**2. 8 MARK WOODS Block 43A Parcel 343 (F18-0450) (P18-1081) (CS)**

Application to modify planning permission for an existing quarry to allow an excavated depth of 50’.

**Figure 1: Aerial imagery showing the general location of the quarry boundaries where a berm is to be constructed to prevent the overflow of quarry water into Meagre Bay Pond and the adjacent wetland. (Source: DoE, 2018 and LIS, 2013)**

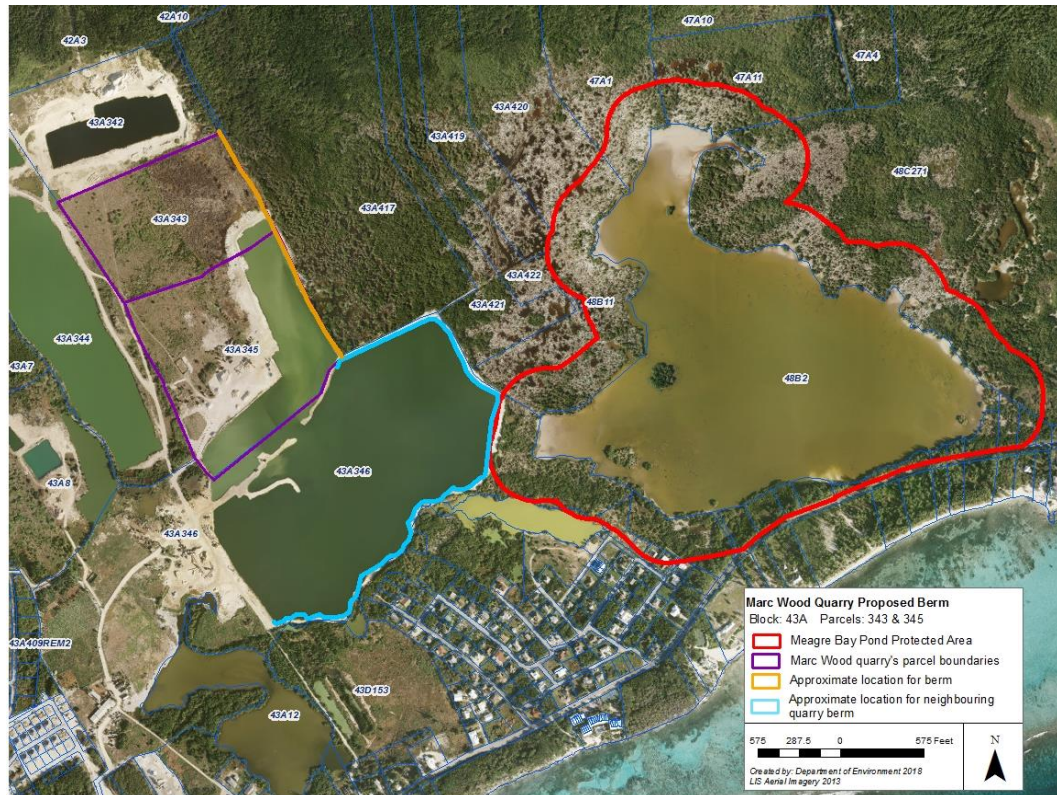
*However, the Department believes that this situation can be mitigated by constructing a berm along the boundaries of both the subject quarry and the interconnected neighbouring quarry in the approximate locations indicated in orange and blue in Figure 1 below. The current access road in the subject parcels is between +1.5 to +3 feet above mean sea level, while the quarry water level fluctuates tidally around an average of about +1 foot. By constructing a berm of sufficient height and width along the eastern boundary of the subject quarry which then connects to a berm on the neighbouring quarry on Block 43A Parcel 346, we believe that the pond's natural hydrological cycle can be restored.*

Given the importance of this mitigation measure to the future health of the Meagre Bay Pond Protected Area, should the Central Planning Authority (CPA) be minded to grant permission for the quarry modification, under Section 41(5)(b) of the National Conservation Law, the National Conservation Council (NCC) respectfully directs the CPA to include as a condition of Planning approval, the requirement to construct a berm on the eastern boundary of the quarry to a height which is sufficient in preventing the overflow of the quarry water into adjacent lands including the pond. In order to complete mitigation before the height of the next wet season, the NCC further directs that the applicant is required to complete the construction of the berm prior to the start of any works on the expansion of the quarry. The exact specifications (height and width) of the berm should be finalised to the satisfaction of the NCC in consultation with the CPA's Aggregate Advisory Committee (AAC).

Figures 1 and 2 above illustrate the breach of Right of Way and buffer.

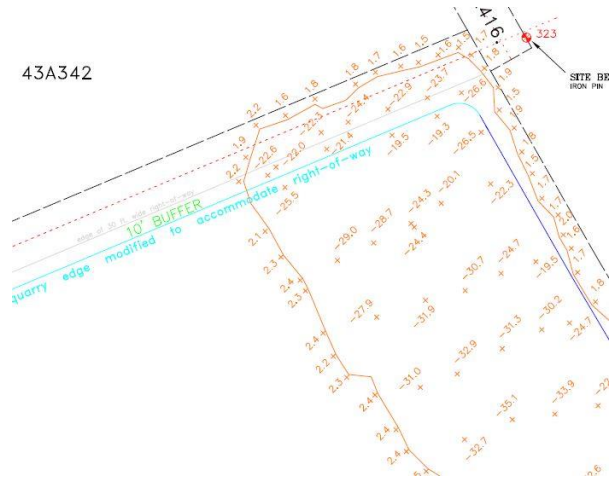
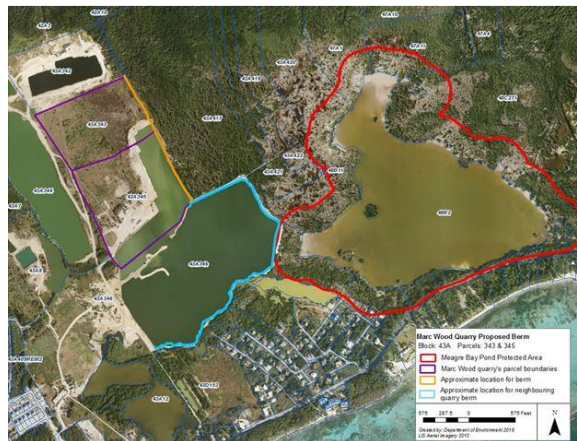
*In the opinion of the AAC, an applicant should demonstrate compliance with previous Planning conditions before receiving approval for additional work. Restitution for breaches of existing conditions should be required in subsequent permission and include the timeliness of restitution. In the case of the applicant's quarry there are two issues that must be corrected.*

- 4. A safety ledge 10 feet in width graded from 0 feet on the outer edge to -3 feet on the inner edge was a condition of the original Planning permission. This condition has not been fulfilled along the eastern and northeastern sides of the quarry lake. The ledge along banks of the lake should be constructed prior to the commencement of excavation in the expanded quarry area. The berm along the eastern side of the lake should be constructed simultaneously using aggregate excavated from the ledge.*
- 5. The private right-of-way which served to grant access to nine parcels northeast of the quarry and the 10 foot buffer between the quarry lake and right of way has been excavated to a depth of 20 feet. The right of way and buffer must be restored prior to the commencement of excavation in the expanded quarry area.*

- 9. Two private right-of-ways which served to grant access to parcels northeast of the quarry have been breached. The route of the southeast access road now runs through sections of property not owned by the applicant. The northwest access road has partially been excavated leaving a 100 foot gap approximately 20 feet deep. This issue should be resolved to the satisfaction of the beneficiary of the registered private access.*
- 10. The existing excavation extends beyond the applicant's property boundary in some areas on the south-eastern side of the lake and encroached into parcels 43D140REM1, 43A14, 43A13, and 43A15. Those areas of the lake must be backfilled in order to construct the berm surrounding the lake (condition 1 above) and to route the registered access through the applicant's property (see condition 6 above).*
